Colibri iMX6

Errata Document

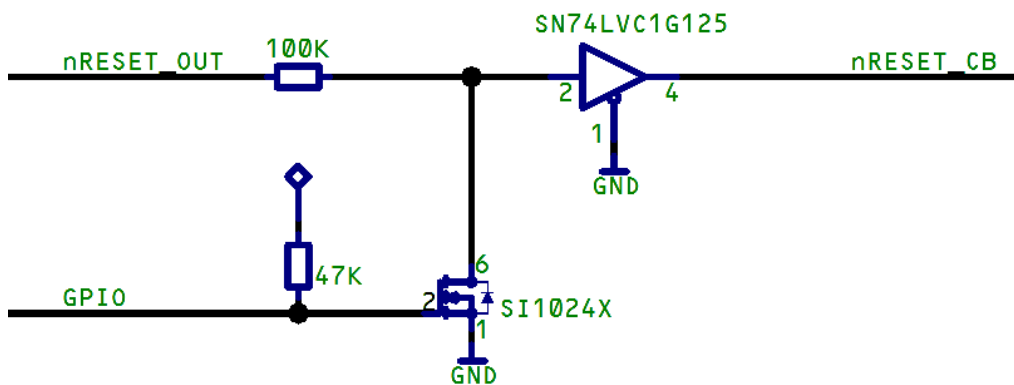
During a software initiated reset cycle, the nRESET_OUT signal is not asserted on the Colibri iMX6 V1.0 module. Unlike other Colibri modules, the nRESET_OUT signal remains the whole time high during the software initiated reset.

During power up as well as hardware initiated reset cycles (by pressing the nRESET_IN/RESET_EXT button), the nRESET_OUT signal gets asserted similar to other Colibri modules. This is not an issue as long as external peripheral devices on the carrier board do not need to be reset during a software reset or no software initiated reset cycles are used on a system.

A possible workaround is implementing a small reset circuit on the carrier board that allows driving low the reset signal by using any free GPIO:

Since on the Colibri iMX6 the reset state of regular GPIOs is configured as input with enabled internal pull up resistor, the transistor will pull down the reset line during a software initiated reset cycle. The bootloader or application needs to reconfigure the GPIO as output and drive it low for releasing the external reset signal.
